NS-NRC-86-3112
SED-SA-86-094

Subject: McGuire Plant BART Model ECCS Analysis with UHI Removed

RESPONSES
TO NRC STAFF
QUESTIONS ABOUT
UHI REMOVAL
AT MCGUIRE

FIGURE I-1 : UHI Model Heat Transfer Coefficient
McQuire $C_D=0.6$ DECIG with Perfect Mixing

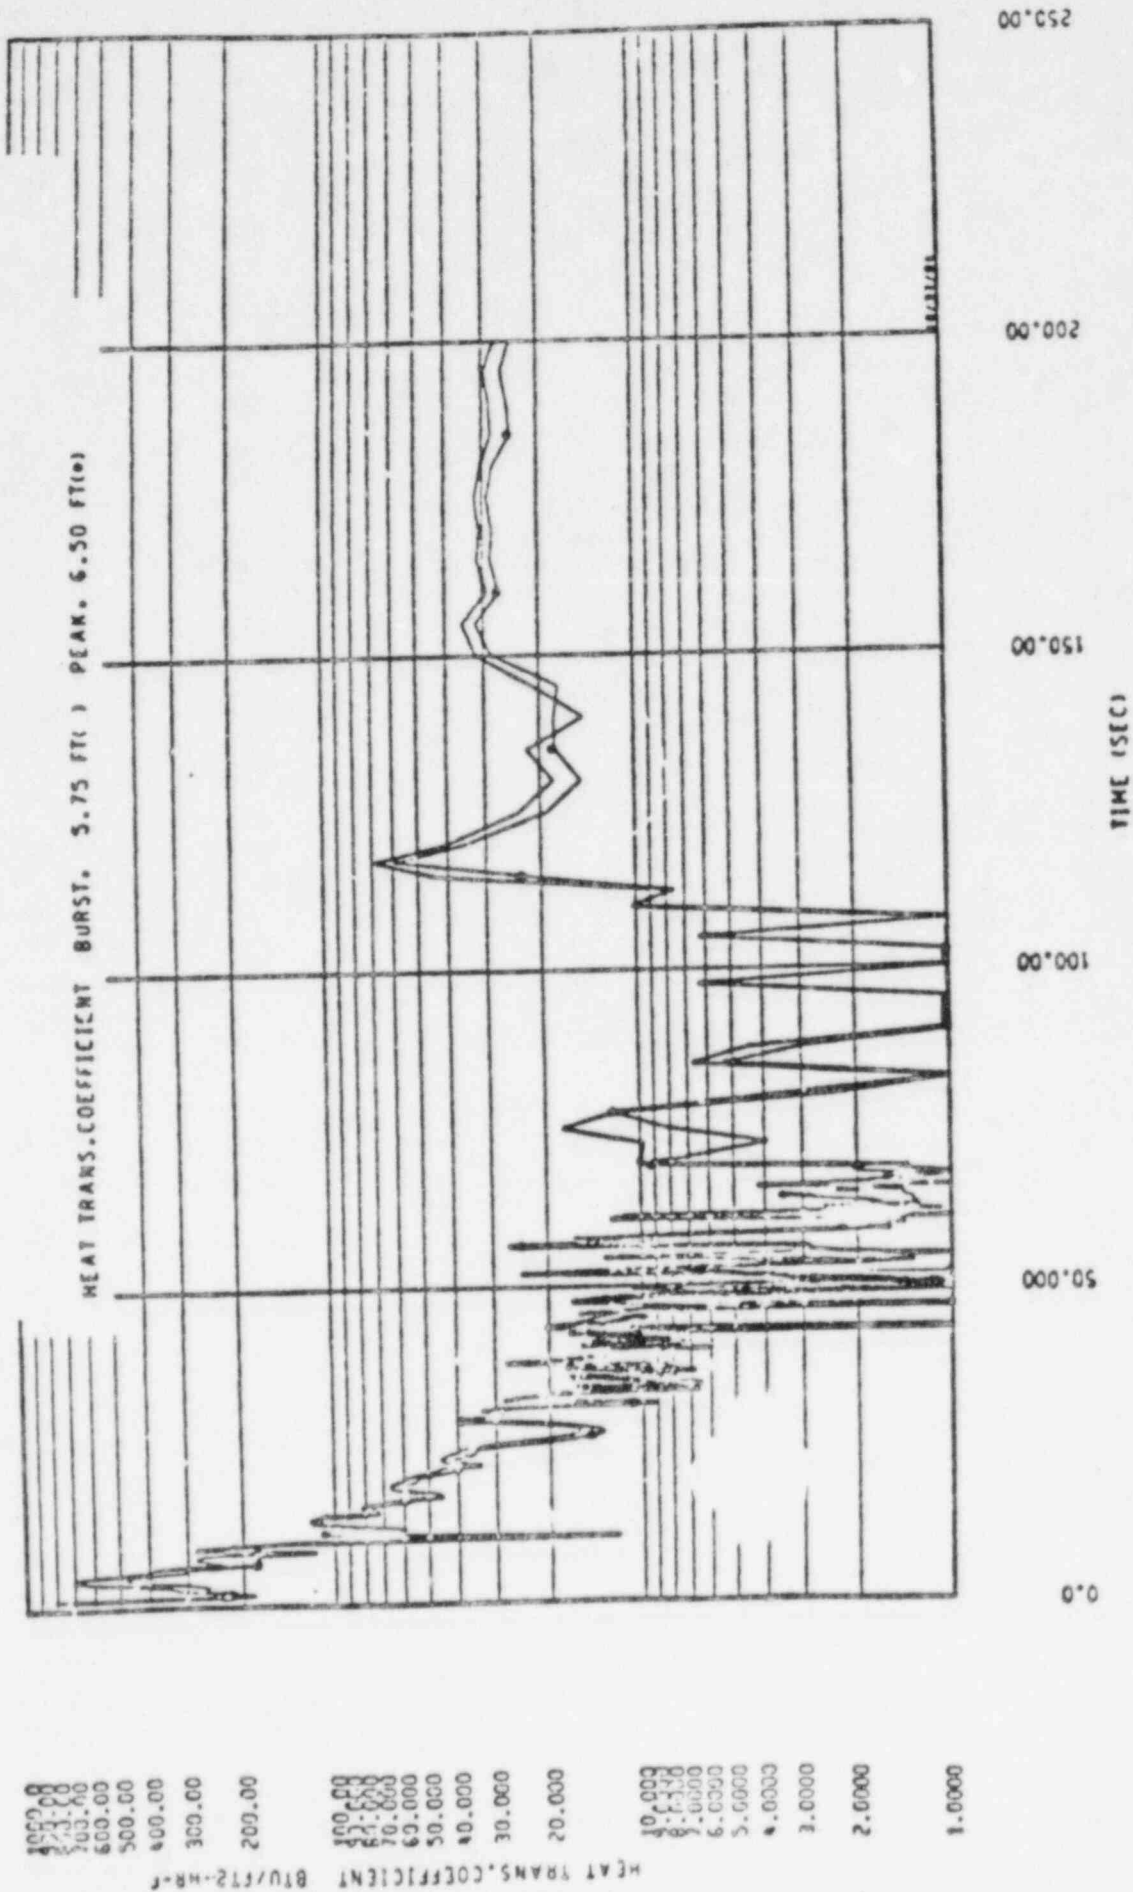
- I. Unrealistic, highly conservative specifications of the UHI large break LOCA evaluation model cause current McGuire Plant calculated peak cladding temperatures (PCT) to be higher with UHI installed than without. Several conservative aspects of the UHI model are discussed below.

The considerations noted above cause the current UHI ECCS model to significantly underpredict the fraction of the core quenched during blowdown. The conservatism of the evaluation model negates much of the PCT benefit UHI has exhibited in tests under LOCA blowdown conditions.

FIGURE I-2 : UHI Support Column at Upper Core Plate

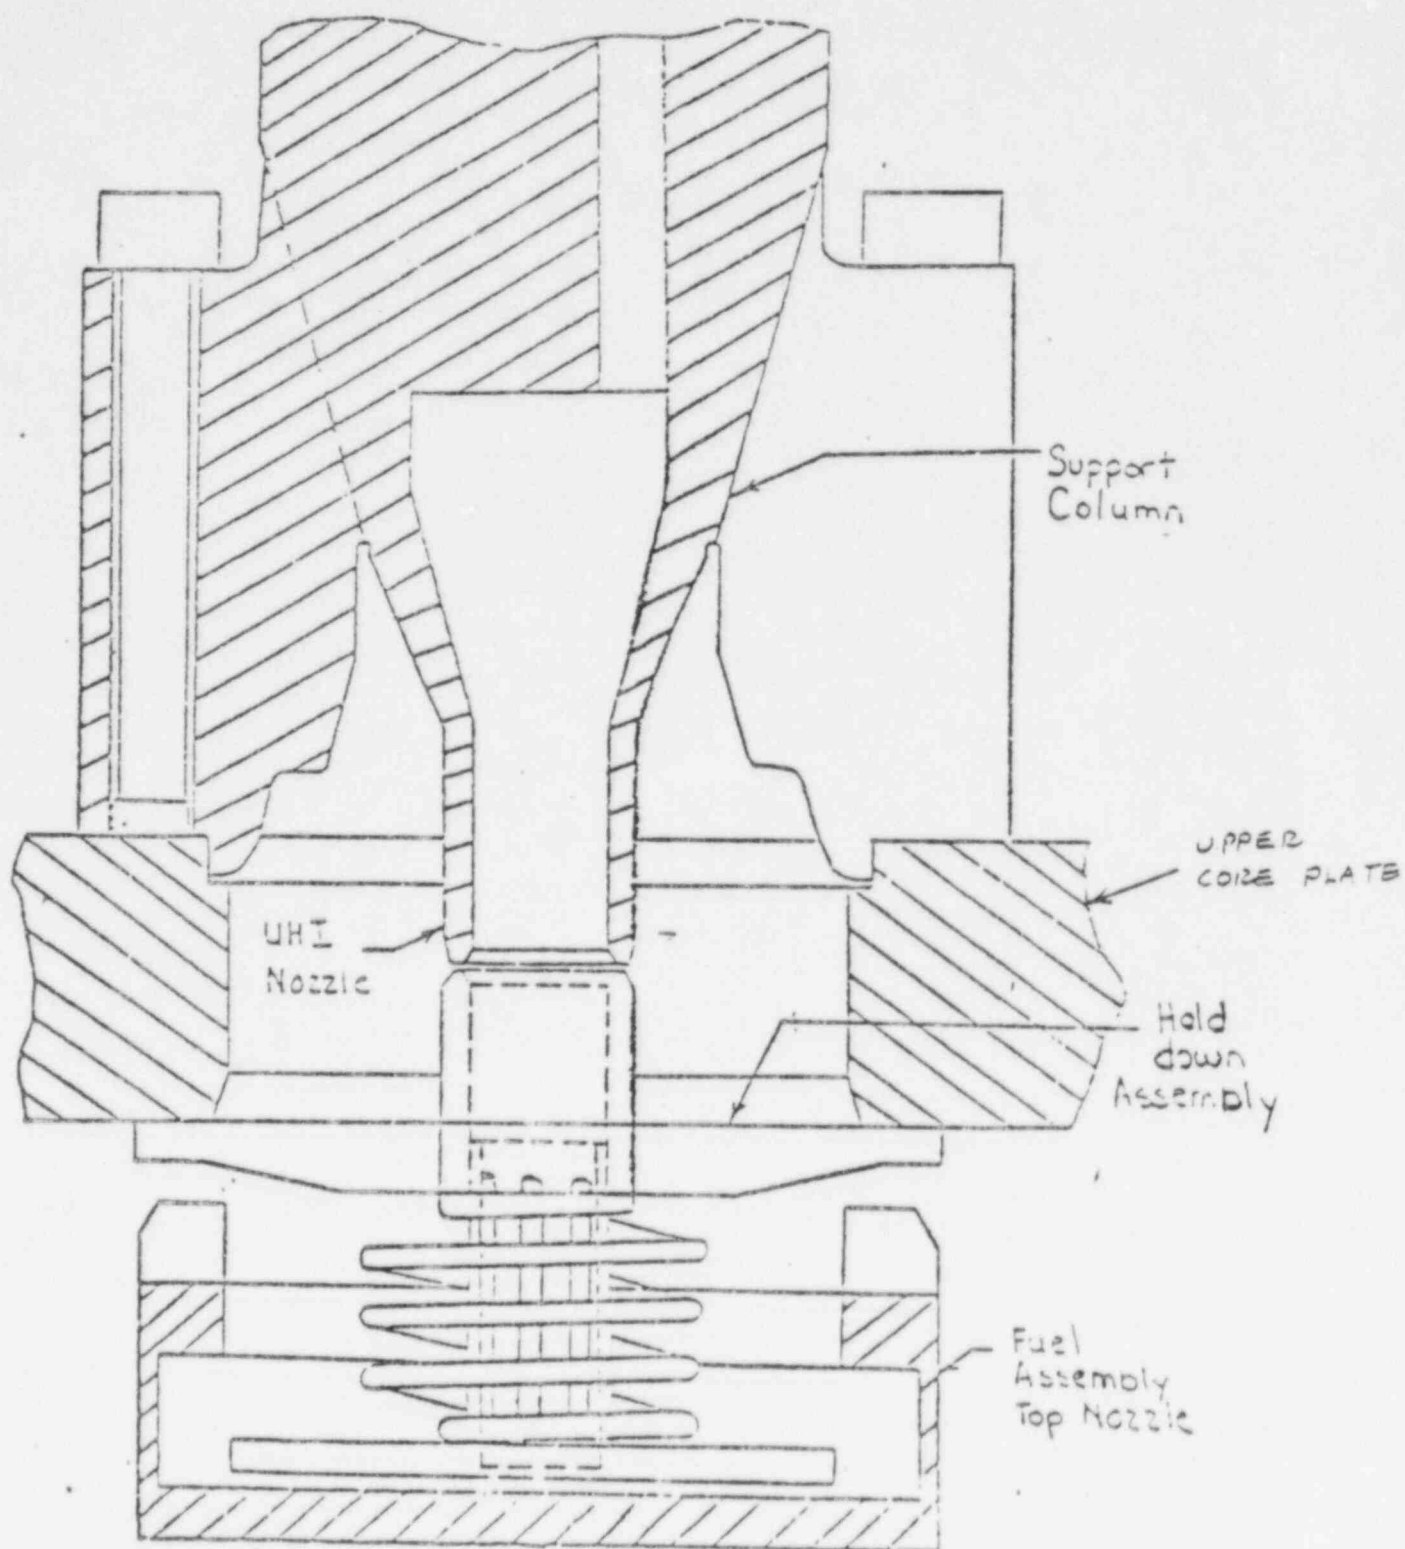
It is worthwhile to pause at this point to review the physical characteristics of the UHI hardware, specifically the flow paths for the UHI support columns and guide tubes. The relationship between the support column and the fuel is shown in the sketch in Figure I-2. The flow from the upper head is delivered directly to the top of the fuel via the support column and hold down assembly. The gap between the hold down assembly and the UHI nozzle is on the order of 0.030 inches.

FIGURE I-3 : Lower Guide Tube Structure

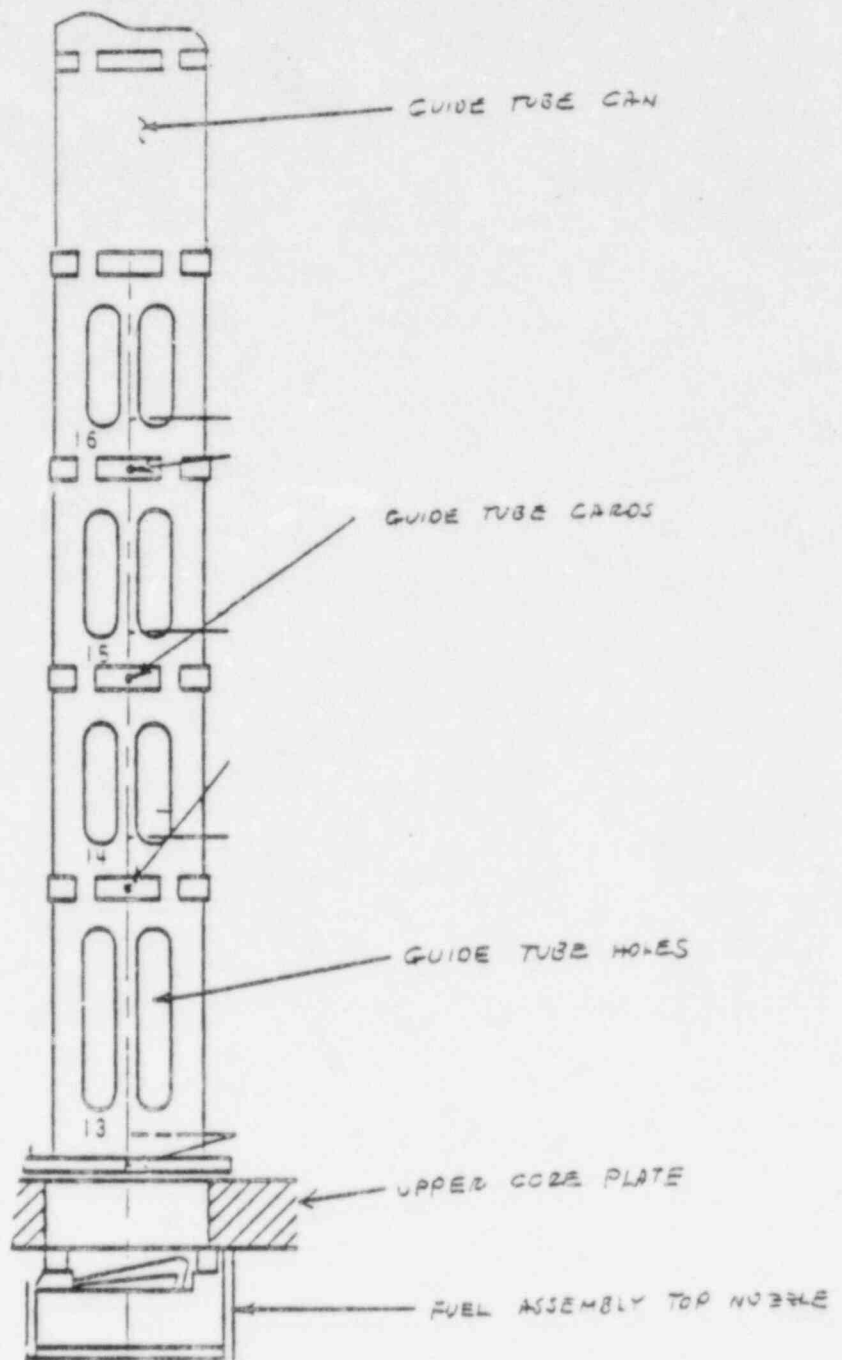
The guide tube, Figure I-3, is observed to be relatively open to the upper plenum near the base. A close examination of the guide tube shows a significant flow area exists at each card location between the volume enclosed by the guide tube and the upper plenum. For these reasons, LOCA models assume that the flow from the guide tube enters the upper plenum. The limiting initial conditions of the UHI accumulator as regards to pressure and water volume are exactly opposite for perfect and imperfect mixing cases. The conservative evaluation model methodology specifies that the bounding accumulator operating values with uncertainties considered be applied to each case individually. Thus, the impact becomes an inability to optimize UHI accumulator setpoints for either the perfect or imperfect mixing case because of the need to secure an acceptable result for both. Were only one upper head mixing assumption necessary, improved UHI Model ECCS performance could be calculated for McGuire by revising accumulator setpoints.

FIGURE II-1 : Core Flowrate with UHI Internals , $C_D=0.6$ DECLG

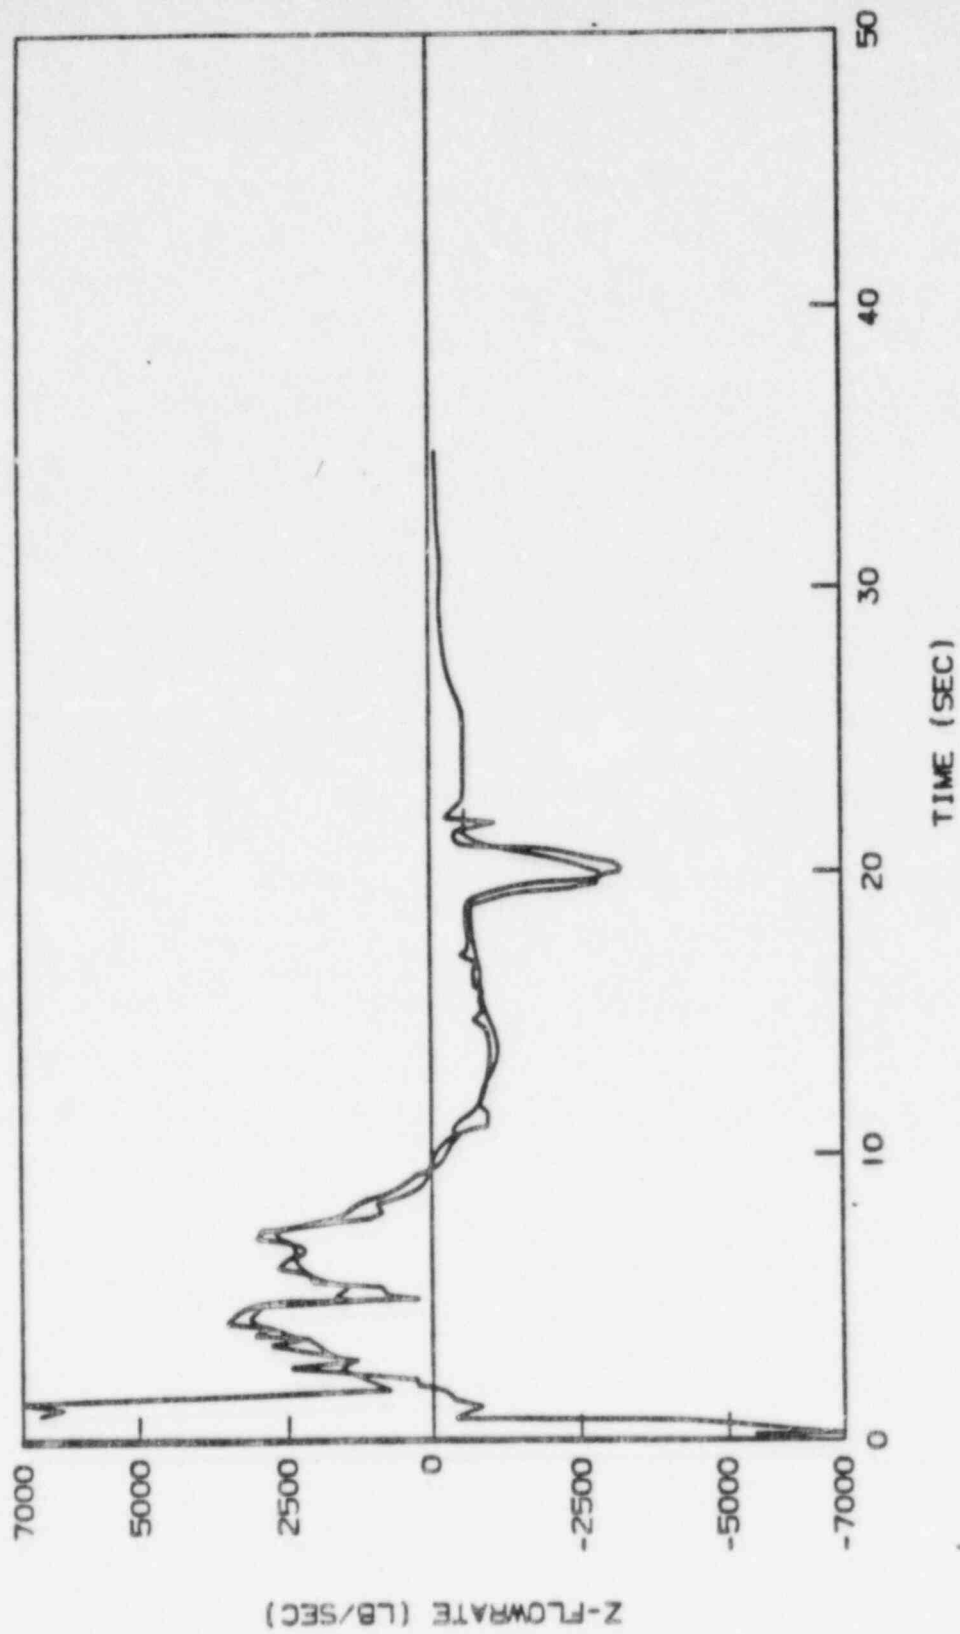
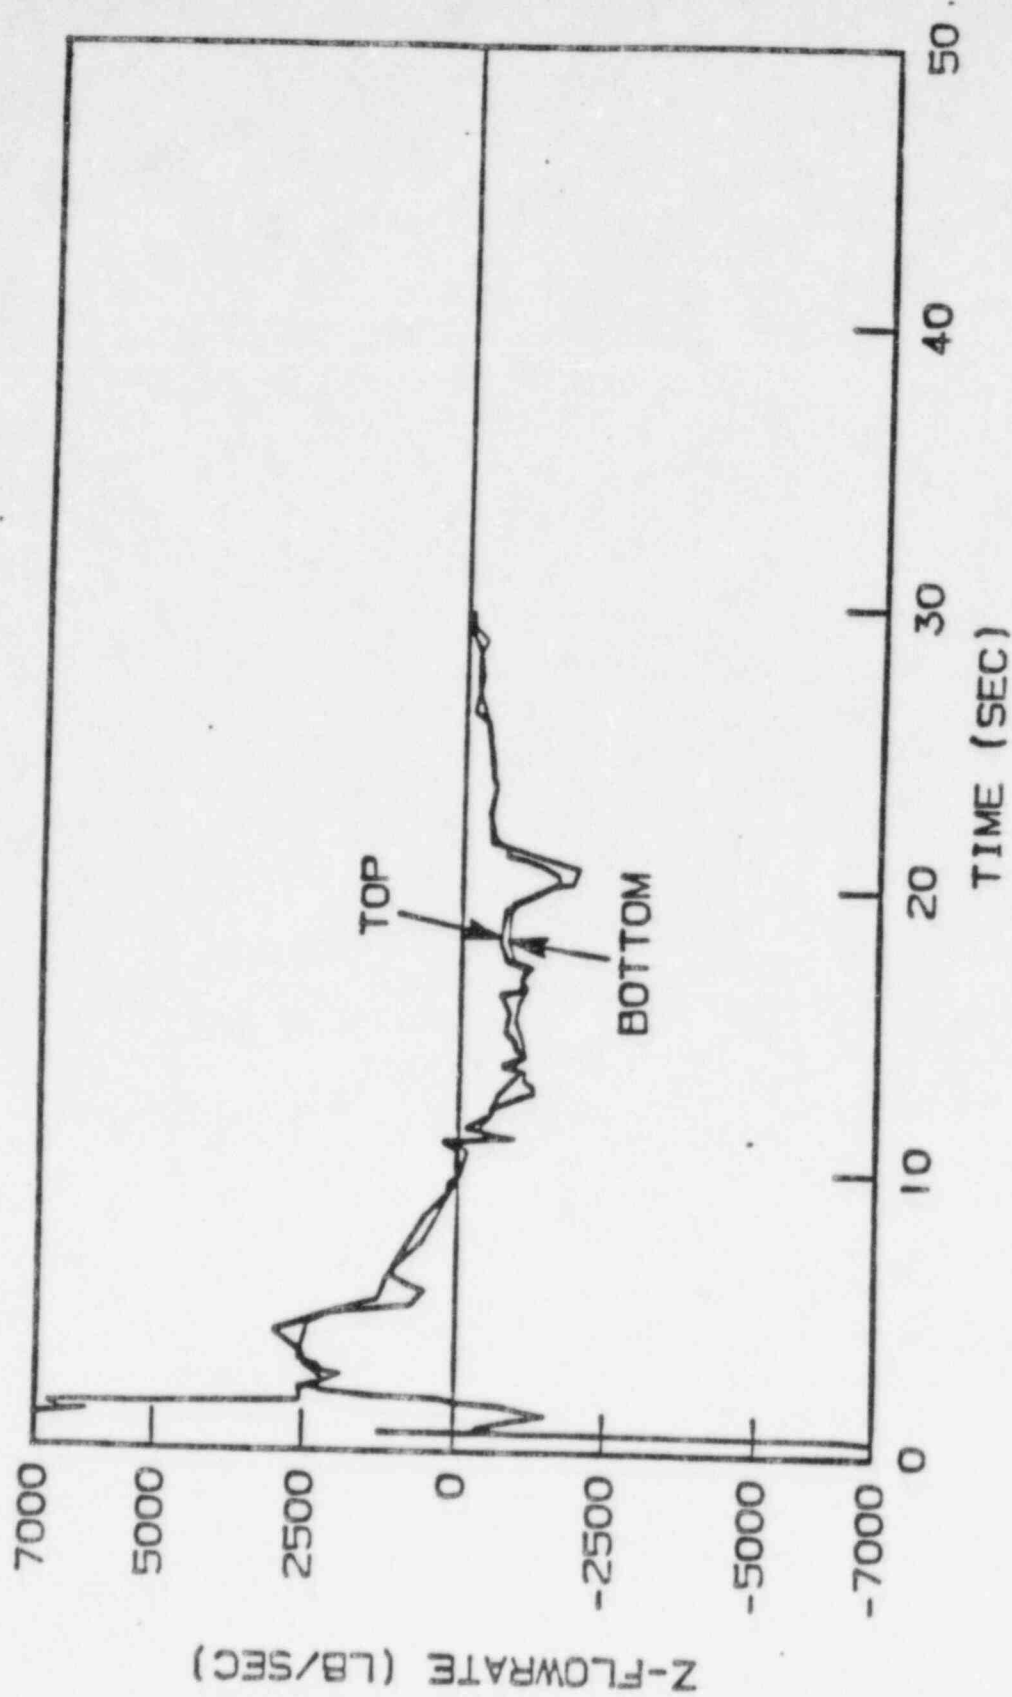
II. UHI plants are equipped with very different reactor upper internals from other Westinghouse 4-loop plants. In order to distribute UHI water equitably throughout the core, 185 of the 193 fuel assemblies were located directly beneath a guide tube or support column which communicates directly with the vessel upper head. The much greater flow communication which exists between upper head and core/upper plenum with the UHI internals design produces enhanced thermal-hydraulic conditions within the fuel during a large break LOCA blowdown. As illustrated in Figures II-1 and II-2 respectively, consider the $C_D = 0.6$ DECLG core flows during blowdown for the McGuire and Callaway Plants computed by the Westinghouse SATAN code. The two units in question are 4-loop plants which are similar in design except that McGuire contains UHI-type upper internals. The core flows are similar for the first few seconds, but from five seconds onward the UHI internals are clearly beneficial. Between 5-10 seconds the UHI internals give a greater water delivery into the upper plenum which produces a notably higher positive (in Figure II-1) core flow rate for McGuire; likewise, at around 20 seconds the enhanced water delivery from the upper head at McGuire permits a much greater negative core flow surge than Callaway exhibits in Figure II-2. These greater core mass flow rates directly cause a significant (greater than 100°F) benefit in calculated peak clad temperature for McGuire relative to Callaway at the end of blowdown.
